**SUBJECT:** COMANCHE PEAK NUCLEAR POWER PLANT, UNITS 3 AND 4  
DOCKET NUMBERS 52-034 AND 52-035  
RESPONSE TO REQUEST FOR ADDITIONAL INFORMATION NO. 5947  
(SECTION 3.7.2)

**RAI NO.: 5947 (CP RAI #226)**

**QUESTION NO.: 03.07.02-23**

**QUESTION NO.: 03.07.02-24**

Figure 21 - Nodes used for PSFSV Roof Slab ISRS (Relates to Figures 3MM-3, 4-6)

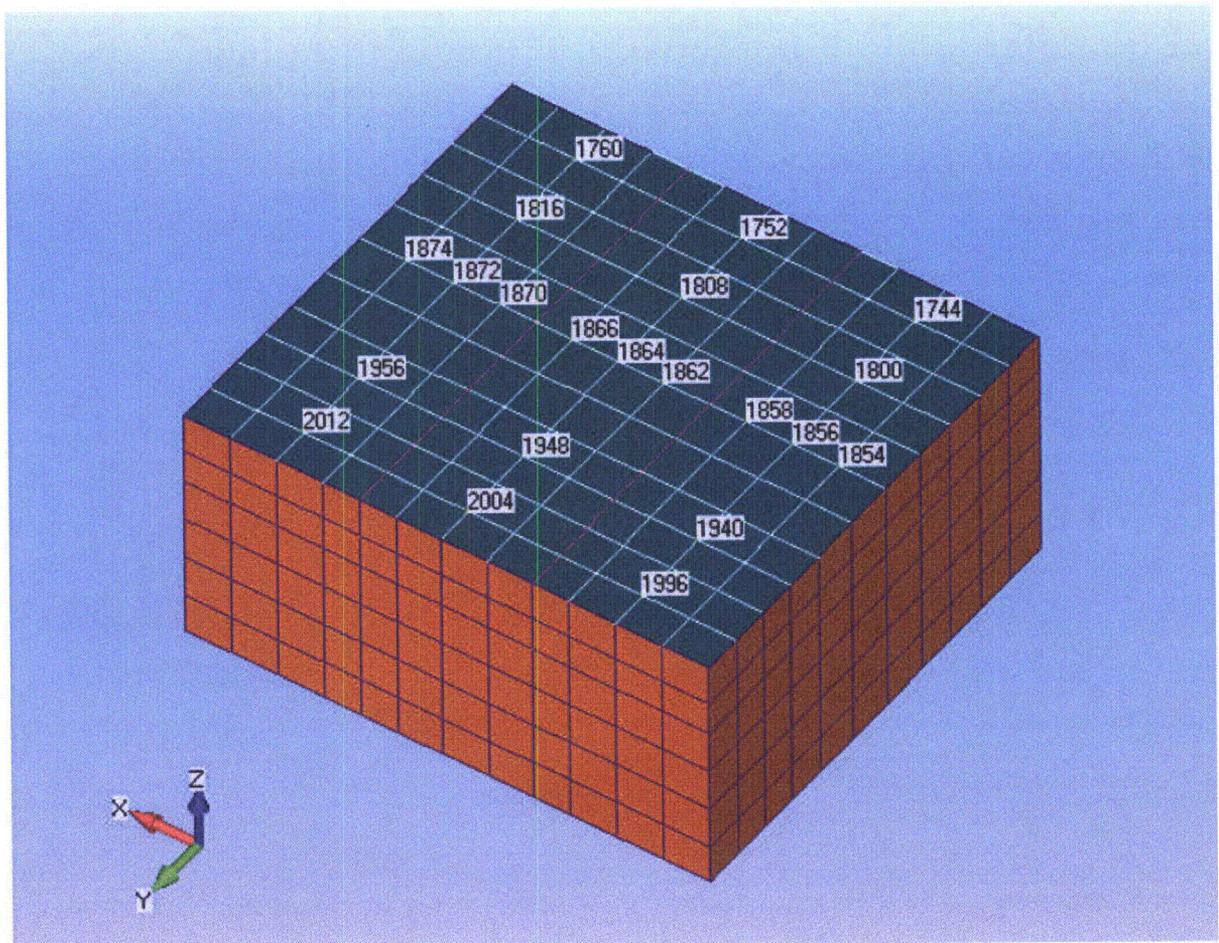
6. The applicant is requested to provide the specific location and node numbers of all nodes used for the generation of ISRS that are shown in Appendices 3KK through 3NN.

**Figure 22 - Comparison of SASSI East-West Transfer Functions to ANSYS East-West Modal Frequencies (Vertical Black Lines)**

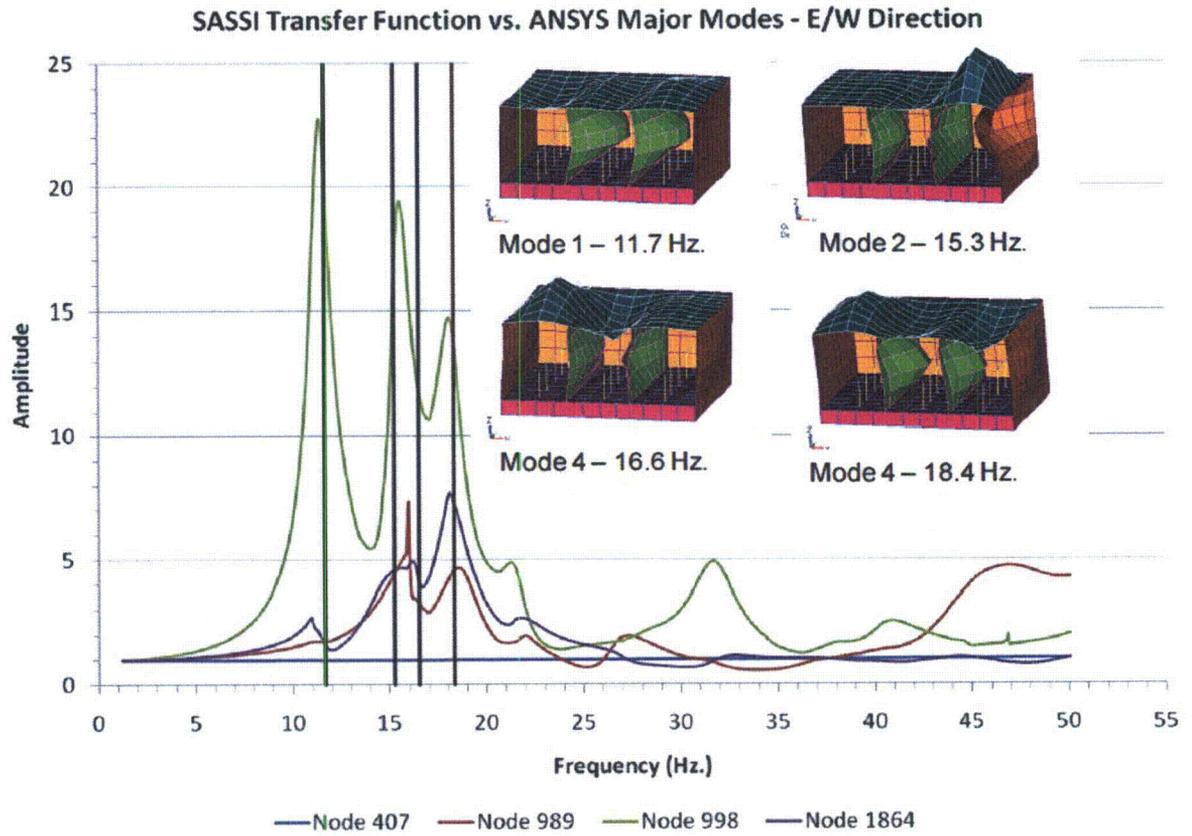
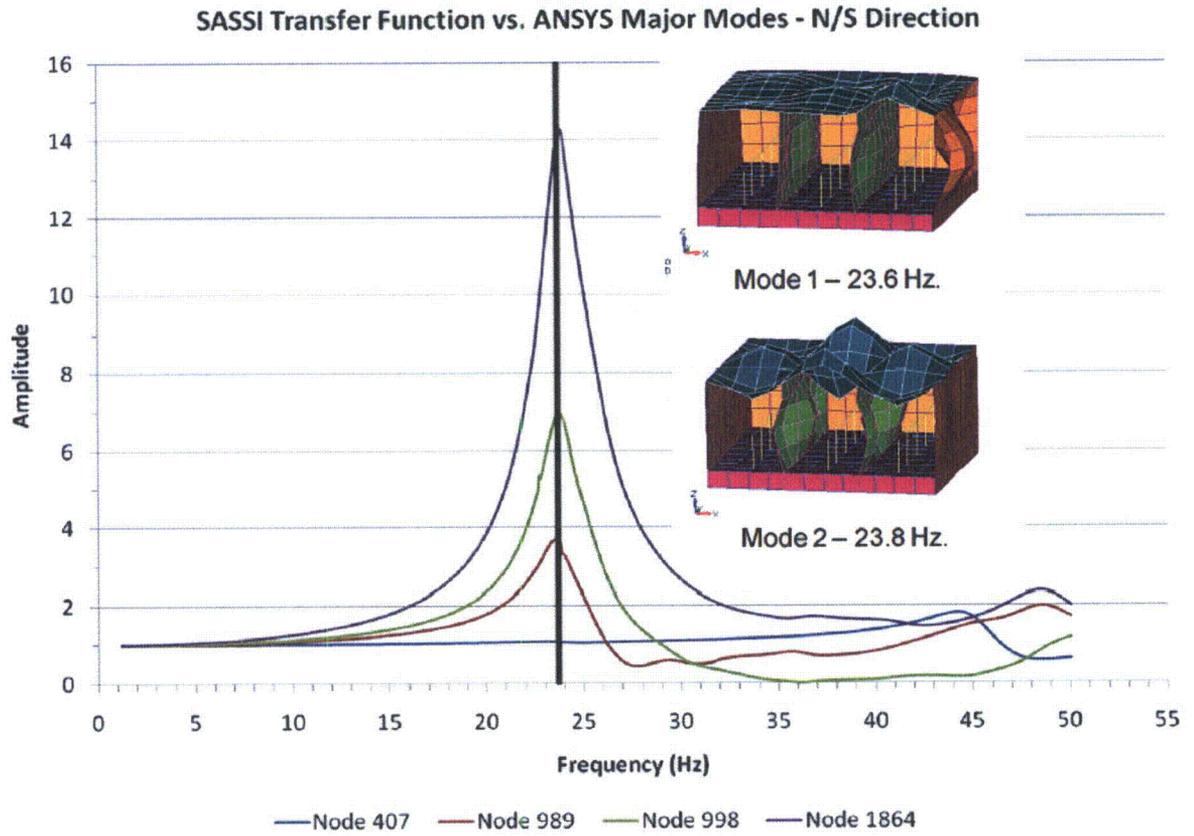
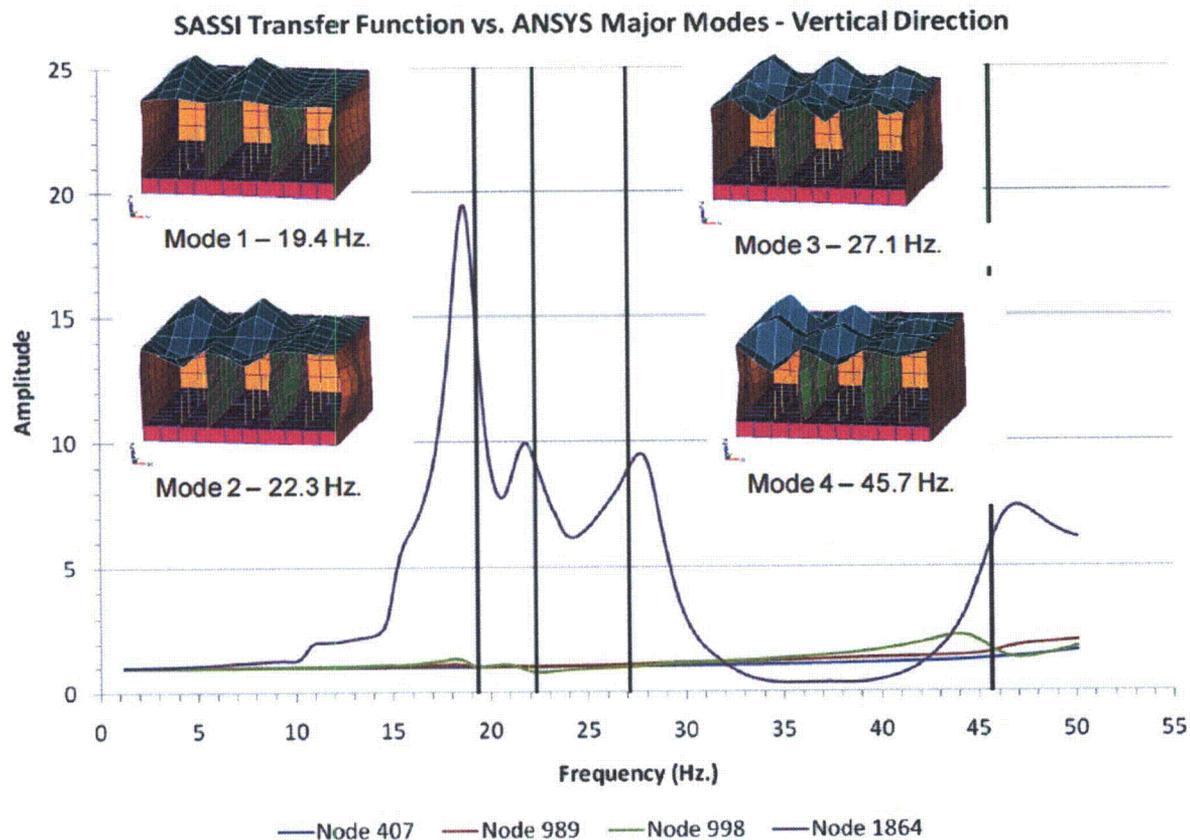
14. In the first paragraph of Subsection 3MM.1 of Appendix 3MM of Revision 1 of the FSAR, the applicant states that "Further, the translation of the model from ANSYS to SASSI is confirmed by comparing the results from the modal analysis of the fixed base structure in ANSYS and the SASSI analysis of the model resting on a half-space with high stiffness. The close correlation between the SASSI transfer function results and the ANSYS eigenvalues results ensures the accuracy of the translation." The applicant is requested to provide these comparisons to the staff for review.

14. Figure 22, Figure 23, and Figure 24 show SASSI transfer functions at selected nodes for the three directions of motion. Major modes from ANSYS are shown on the plot by vertical lines. The ANSYS mode shapes are also shown for each major mode. ANSYS un-damped major modes differ from SASSI damped major modes (based on the transfer function peaks) by less than 1% in the north-south and east west directions and by less than 5% for the first major modes in the vertical direction. Note that eigenvalue analyses in ANSYS compute un-damped natural frequencies, whereas ACS SASSI inherently considers damping in computation of transfer functions. This analysis demonstrates that the SASSI and ANSYS tank vault models are comparable.
